E8267D-17

S E R V I C E N O T E

E8267D Digital Signal Generator

**E8267D w/UNX – Missing 1GHz cables and 1GHz out connector on rear panel.
This only apply on the rear panel that had 1GHz out connector hole.**

Photo Bottom View

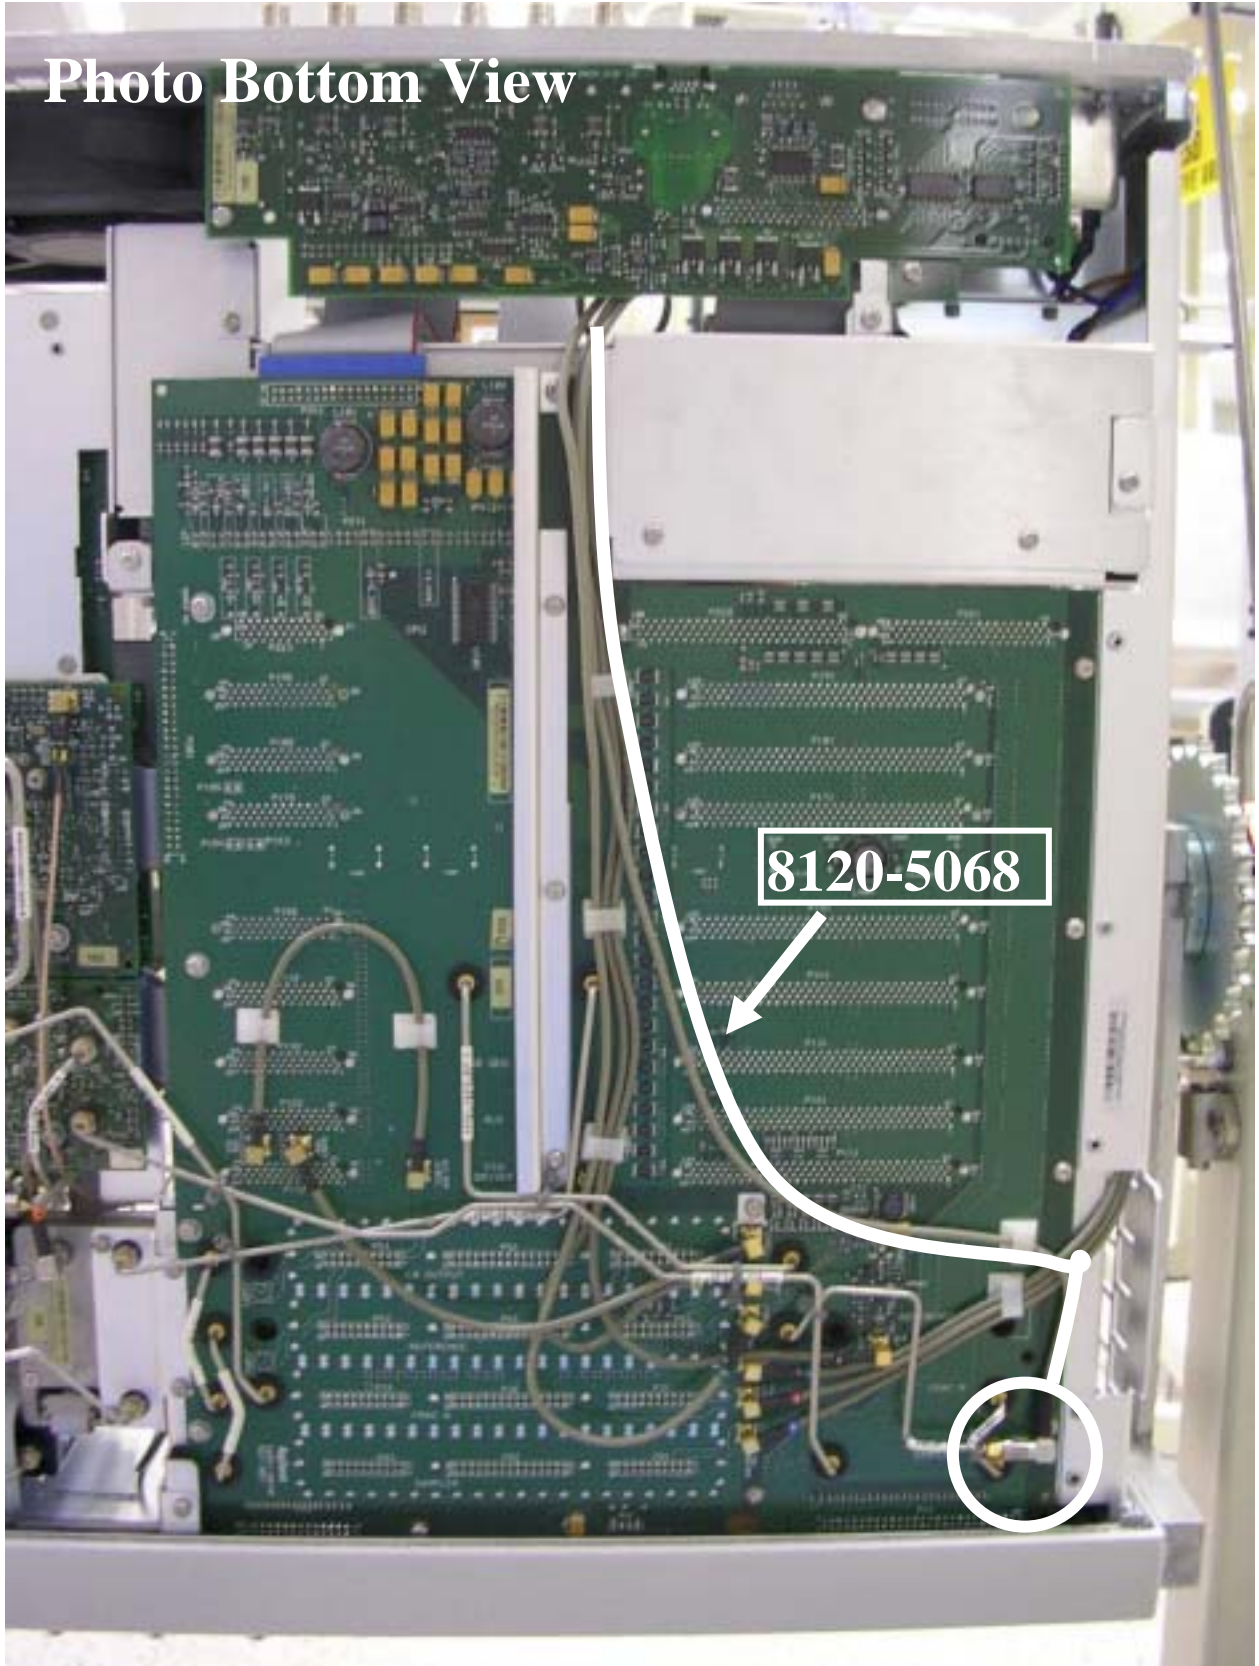
1. Check the instrument option. Make sure the instrument have the UNX option.
2. Check the rear panel. Make sure there is '1GHz Out' hole available.
3. Remove the outer and inner cover of the instrument follow the procedure in the service manual.
4. Connect the cable 8120-5068 as in the photo bottom view. Please follow the cable routing that highlighted in the photo.
5. Assemble the adapter 1250-1753 to the rear panel '1GHz Out' hole. Fix the 1250-2759 cap to the adaptor. Please refer to photo 1GHz out external view.
6. Connect another end of cable 8120-5068 to adapter 1250-1753 at rear panel. Please refer to photo inner view of rear panel.
